Assessment of the Surveillance Program of the High-Level Waste Storage Tanks at Hanford

Robert J. Catlin, Deputy Director
Office of Environmental Compliance and Overview
Office of Environment

MARCH 1980

Report to the
U.S. Department of Energy
Assistant Secretary for Environment
Washington, DC

FIGURE 15.
HANFORD SS TANK FARM FACILITIES
CRITERIA USED TO CLASSIFY QUESTIONABLE INTEGRITY TANKS.

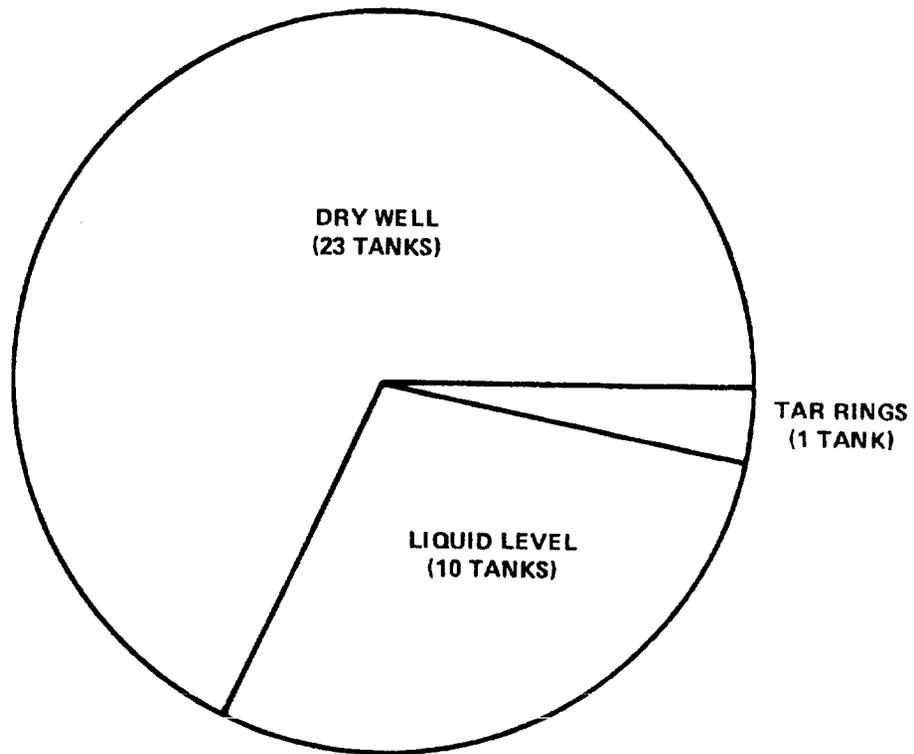
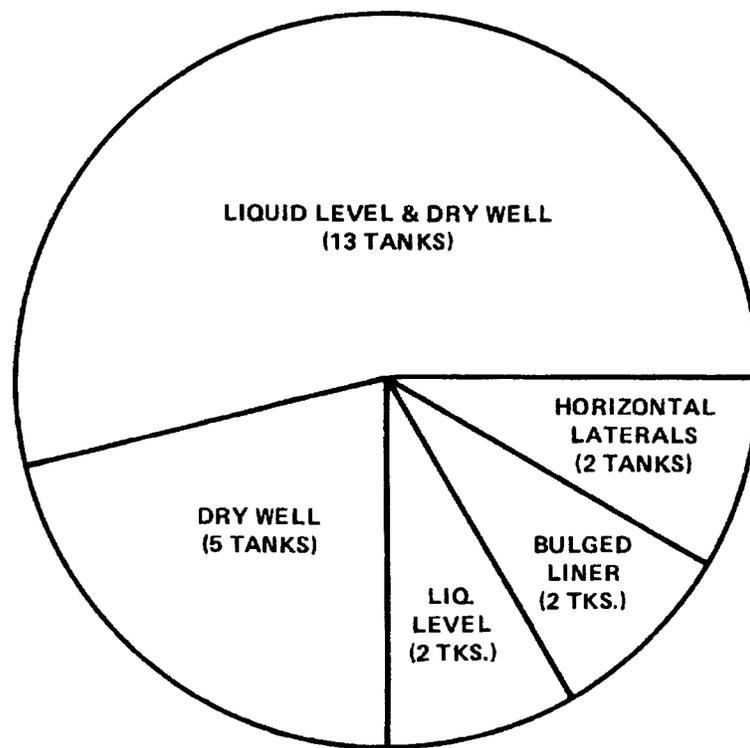
example, Figure 15 shows that single monitoring system criterion was used to classify present questionable integrity tanks despite evidence that corroborative information from other monitoring systems was also taken into account. It is interesting to note, as shown in Figure 17, that a dry well criterion has been used more often in recent years, presumably due to removal of liquids during waste solidification that made the liquid level monitoring systems non-functional.

**FIGURE 16.
HANFORD SS TANK FARM FACILITIES
CRITERIA USED TO CLASSIFY CONFIRMED LEAKING TANKS.**

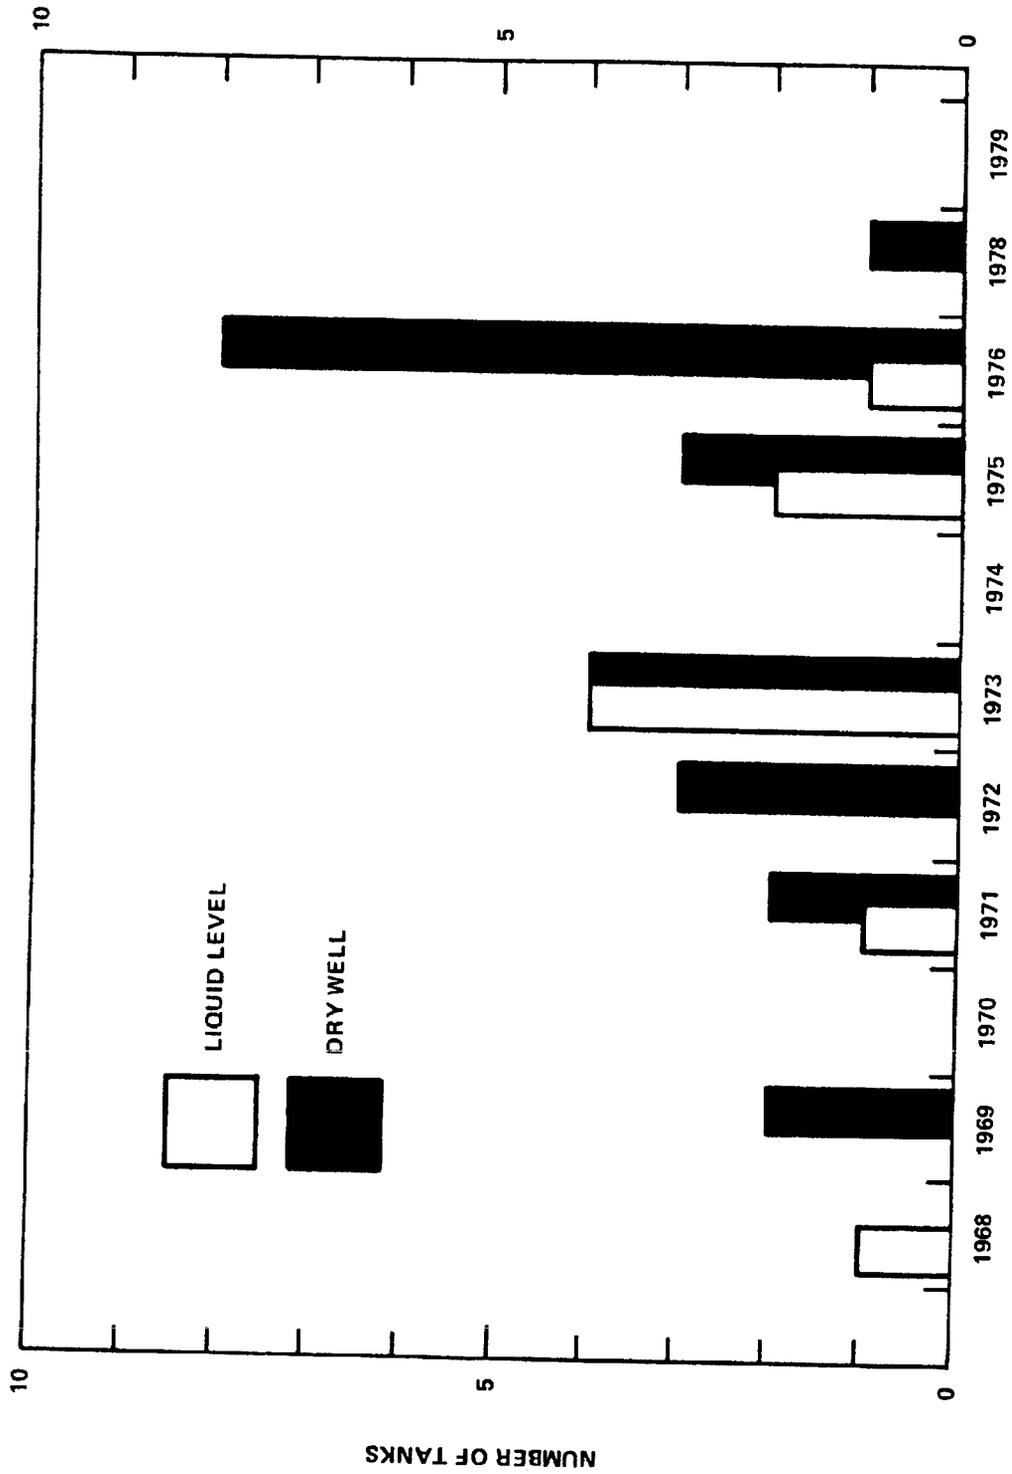
Figure 16 shows that dual monitoring system criteria were applied to only about 50 percent of the confirmed leaker determinations despite information received during this assessment that dual criteria were necessary for this classification. The differences in application of the working guidelines lie, of course, in the degree and validity of monitoring system indications. The need for flexible criteria at Hanford is recognized but such criteria must be formally documented to ensure uniform and consistent tank classification.

FIGURE 22.
LEAK MONITORING STATUS - HANFORD SINGLE-SHELL TANKS.

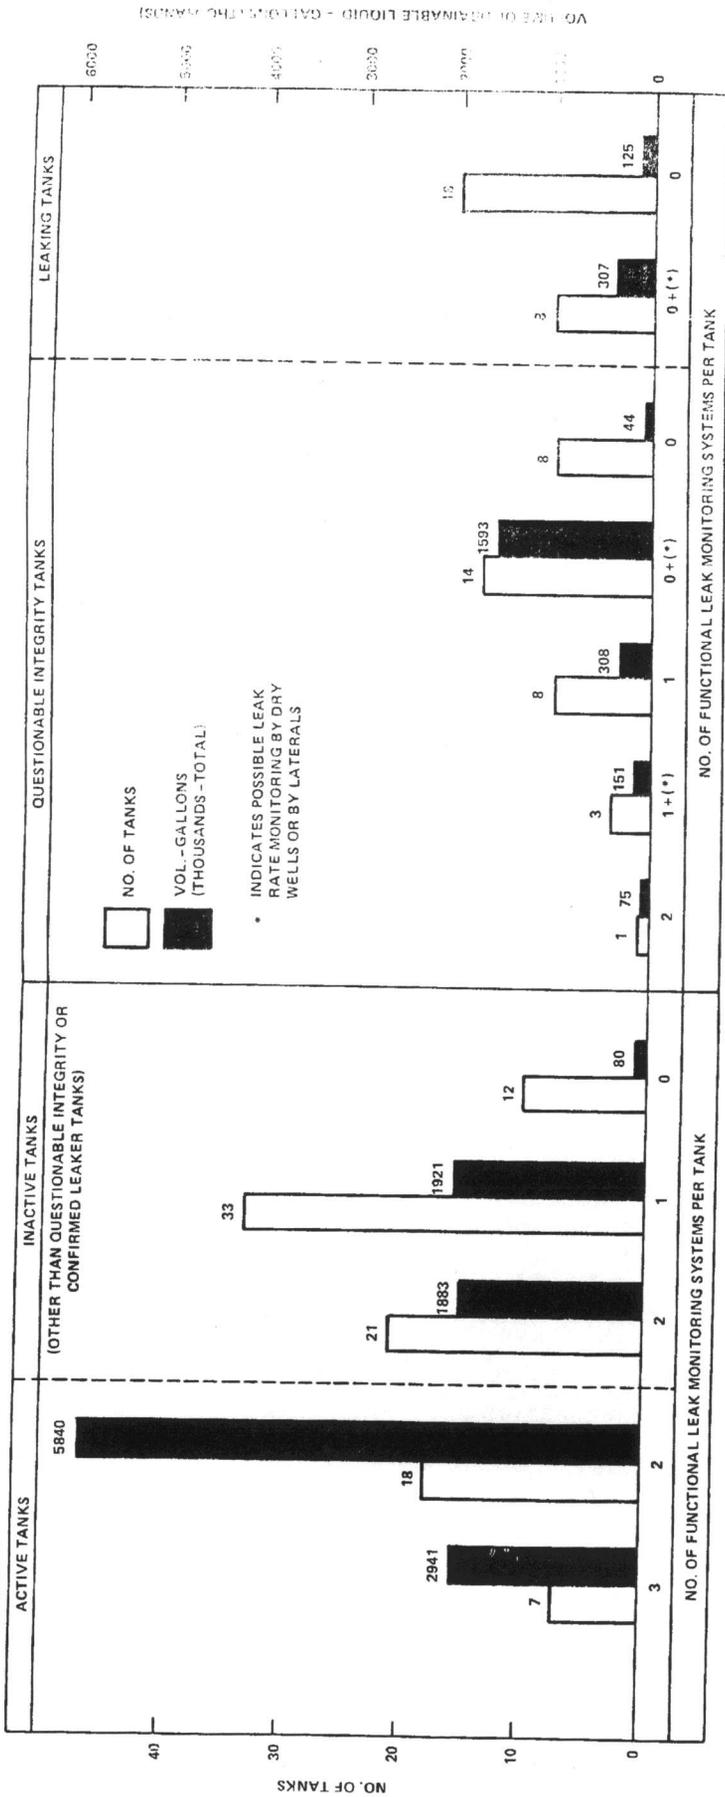
As shown on the left in Figure 22, 12 of the 34 questionable integrity tanks have at least one functional leak monitoring system but only one of these 12 tanks is monitored by two separate leak detection systems. Three of the 12 tanks, the second group from the left identified by an asterisk in Figure 22, also have dry well monitoring systems but, because of dry well radioactivity in the wells, these systems are adjudged functional only to a limited degree for monitoring further indications of leakage or movement of radionuclides in the soil.

Of the remaining 22 questionable-integrity tanks, 14 have contaminated dry well systems that may be functional to a limited degree for monitoring movement of radionuclides through the soil. It is a matter of concern that these 14 tanks with marginal monitoring capability contain approximately 1.6 million gallons of drainable radioactive waste liquid. As for the other inactive tanks previously discussed, the liquid-level leak monitoring systems for these tanks have become unresponsive because of removal of supernatant. Removal of the remaining substantial quantities of interstitial liquid must await the procurement and installation of more sophisticated pumping equipment, which is scheduled over the next several years. The outer eight tanks have no functional leak monitoring system but contain practically no drainable liquid.

As shown on the right in Figure 22, 8 of the 24 confirmed leaker tanks have contaminated dry well or lateral systems that are functional to a limited degree for monitoring further indications of leakage or movement of radionuclides in the soil, whereas 16 such tanks have no functional monitoring system. All the supernatant has been removed from these tanks. Half of the drainable interstitial liquid remaining is tightly held in sludge in 22 tanks. The other half is held in large volumes of salt cake in two tanks, which are scheduled for jet pump installation starting in fiscal 1981. The lack of leak monitoring for these tanks is not of concern unless the interstitial liquid becomes less bound to the solids in the tanks or substantial intrusions occur. It should be noted, as stated at the beginning of this chapter, that all tanks are adequately monitored for intrusion and that such monitoring would detect the appearance of supernatant from whatever source.
